APPENDIX 1-F
Comments to the Draft Groundwater
Sustainability Plan and Responses

**Response to Comments Summary and Master Responses to
Public Review Draft of the Vina Subbasin Groundwater Sustainability Plan
Released September 2021**

**Groundwater Sustainability Plan
Public Review Draft- September 2021
Comment Tracking Table**

Figure ES-7: Representative Monitoring Site For Groundwater Levels With Relationship Of Measurable Objectives, Minimum Thresholds and Operational Range

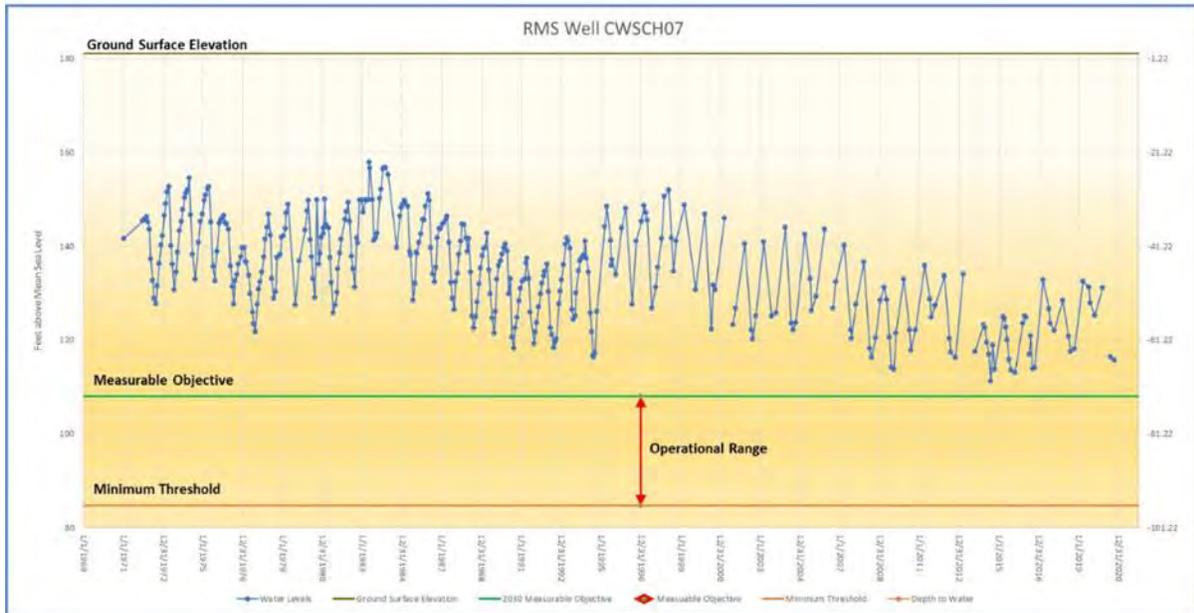
The sample hydrograph is one of several that I have reviewed in Appendix 3-b of the GSP that have disturbing MO and MT levels. The MO is below the historic low, not the appropriate level to designate the top of the operational range. The MT as defined in other parts of the GSP, is purported to designate “the point at which Undesirable Results may BEGIN to occur.” But undesirable results will begin much earlier in the operational range. The historic low of this hydrograph is above the 80’ max rooting depth of native phreatophytes. The MT is significantly lower than 80’ bgs. Furthermore, the lower water table will dewater longer reaches of streams earlier in the season and persist later in the year. The operational range proposed is pessimistic in meeting goals that would avoid triggering Undesirable Results. Wise resource management strives to improve conditions that have been degraded by human development. Accepting degraded status quo or planning for increased degradation may be realistic given the human inclination to ambitiously convert resources into useful products. But the term “sustainable” implies we have the capacity to identify and honor carrying capacity while devising demand flexibility strategies to meet evolving climate conditions. Robust Management Objectives reduce the probability of careening toward Management Thresholds. Our MO levels can strive to improve conditions without risk of State management takeover. Water code § 354.30. Measurable Objectives (g) An Agency may establish measurable objectives that exceed the reasonable margin of operational flexibility for the purpose of improving overall conditions in the basin, but failure to achieve those objectives shall not be grounds for a finding of inadequacy of the Plan.

77	Jim Brobeck (5)	Aqualliance			249 figure ES-7	249 The sample hydrograph is one of several that I have reviewed in other parts of the GSP that have disturbing MO and MT levels. The MO is below the historic low, not the appropriate level to designate the top of the operational range. The MT as defined in other parts of the GSP, is purported to designate "the point at which Undesirable Results may BEGIN to occur." But undesirable results will begin much earlier in the operational range. The historic low of this hydrograph is above the 80' max rooting depth of native phreatophytes. The MT is significantly lower than 80' bgs. Furthermore, the lower water table will dewater longer reaches of streams earlier in the season and persist later in the year. The operational range proposed is pessimistic in meeting goals that would avoid triggering Undesirable Results. Wise resource management strives to improve conditions that have been degraded by human development. Accepting degraded status quo or planning for increased degradation may be realistic given the human inclination to ambitiously convert resources into useful products. But the term "sustainable" implies we have the capacity to identify and honor carrying capacity while devising demand flexibility strategies to meet evolving climate conditions. Robust Management Objectives reduce the probability of careening toward Management Thresholds. Our MO levels can strive to improve conditions without risk of State management takeover. § 354.30. Measurable Objectives (g) An Agency may establish measurable objectives that exceed the reasonable margin of operational flexibility for the purpose of improving overall conditions in the basin, but failure to achieve those objectives shall not be grounds for a finding of inadequacy of the Plan.	Comment noted. See MO/MT Master Response and GDE Master Response
